PROPOSED WORKS : **Conversion of existing property into 3 x No. self-contained apartments.**

ADDRESS : **23 Mead Lane, Bognor Regis, PO22 8AP.**

Garage Infill Wall

Revision B – 13 May 2021

PARTIAL EXISTING NORTHERN ELEVATION

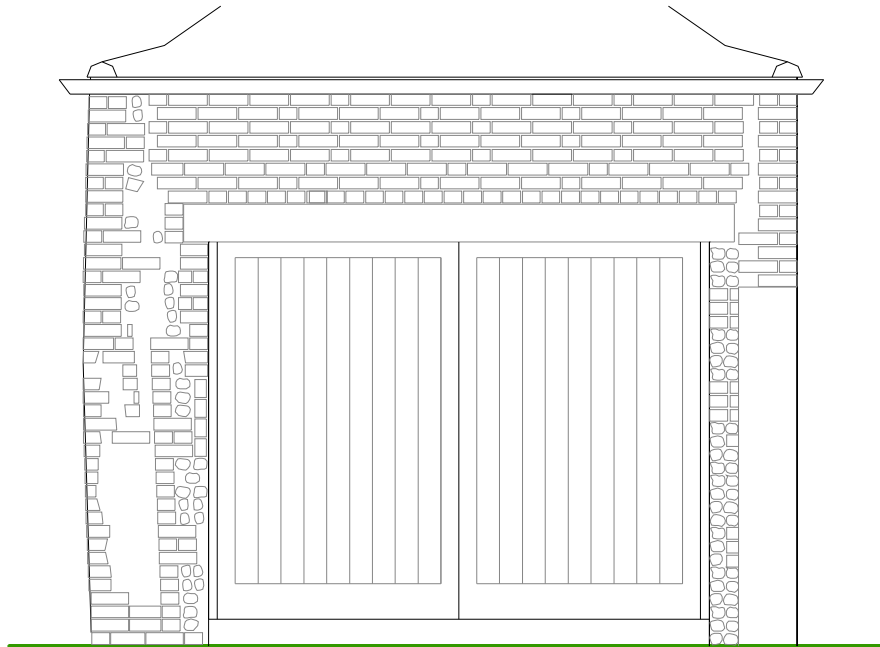
- 1.3 Since the original report the internal space and structure of the garage has been cleared out and fully exposed, the situation regarding the state of repair of the rear facing garage wall and in turn the lateral stability of the flint wall facing Mead Lane has been found to be more critical than originally thought.
- 1.4 The site was inspected by Mr Jim Henn of Arun Building Control recently where he raised concerns and asked for further investigation following the exposure of the structure.
- 1.5 The structural engineer visited the site and called for more extensive remedial work, not only to ensure the stability of the infill portion of the wall but also the long-term stability of the existing flank wall which has also moved over the years.

- 1.6 The engineer has stated *“The pre-existing movement to the existing brick quoin to the north east corner is such that it will not be possible to bond new brickwork to it whilst maintaining the correct lines and levels for the north elevation masonry. In addition, from our recent inspection, it is not considered possible to bond any new brickwork to the already deformed existing masonry on the north elevation and which includes the infill brick and flintwork. Any attempt at doing so will destabilise the wall and corner of the building further. In addition, the masonry over the garage door has moved and is unlikely to be able to be safely supported in the temporary condition without risk of partial or total collapse.”*

- 1.7 He further states that *“In order to safeguard the longer term stability of the garage structure and to extend its longevity for the foreseeable future we strongly recommend that the existing brick quoin to the north*

east corner of the garage structure is rebuilt in its entirety, returning this along the north elevation and replacing poorly formed and structurally unsound flint and brick infill. The masonry over the garage doors should also be rebuilt in order to provide a robust and stable structural arrangement. The existing flint and brick elements cannot be retained as to do so will leave the structure in an inadequate structural condition and at risk of potential further movement or collapse. The rebuilding and remedial work could be achieved by reusing some existing materials or similar reclaimed materials."

- 1.8 To summarise he says that *"Without undertaking the works recommended above the stability of the north and east elevations of the structure will be compromised possibly resulting in further movement and even partial collapse. Undertaking the recommended works as part of the proposed conversion work will, in our considered opinion, provide a robust structural form which should not require further repair in the medium term future, thus securing that part of the building for the future and maintain the built heritage of the rest of the structure without need for more significant remedial work"*

- 1.12 The proposal is therefore to re-build this portion of the wall in its entirety to safeguard the long-term stability of the structure and provide a more robust form which will reduce the need for medium term repair which it would otherwise need.

PARTIAL PROPOSED NORTHERN ELEVATION

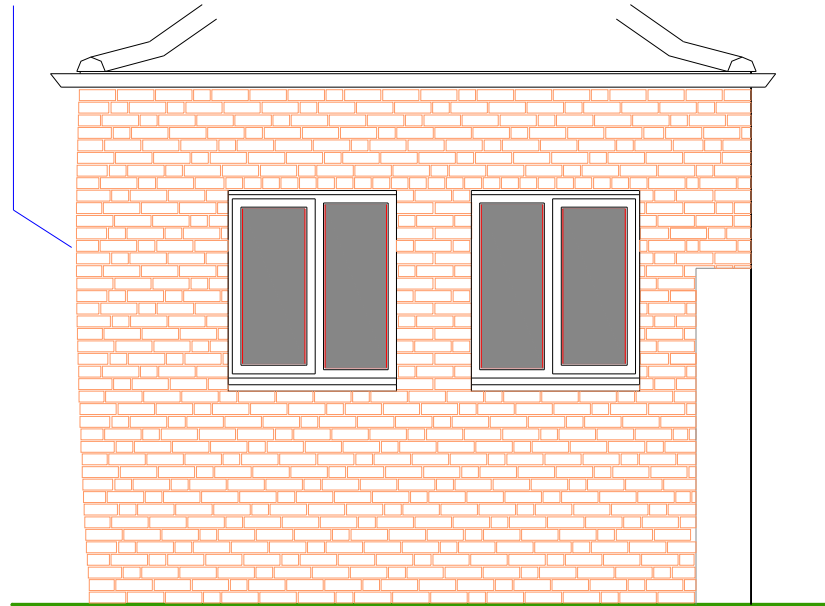
The replacement wall is to be built with the same bow and lean as existing to be able to tie in the flint walling to the flank wall.

- 1.13 The new brickwork bonding pattern chosen is to match the existing style evident above the garage door with a 'Sussex' bond using wherever possible reclaimed bricks from this and other parts of the building. Pointing is to be flush type, cement:sand mortar, again to match with existing.

- 1.14 As will be seen with the submitted elevation, the lean and bow of the wall will be replicated and built in to the new design, not only to keep the character of the structure but also to allow for the smooth bonding of the flintwork flank wall facing Mead Lane.

- 1.15 Lintols above the new windows will be IG or CATNIC type which are not visible externally.
- 1.16 It is hoped that not only will this secure the long term stability of the building but it will also present an appearance that has kept the essence of the renovated wall which is in-keeping with the main structure and surrounding buildings within the Hotham Park Conservation Area.
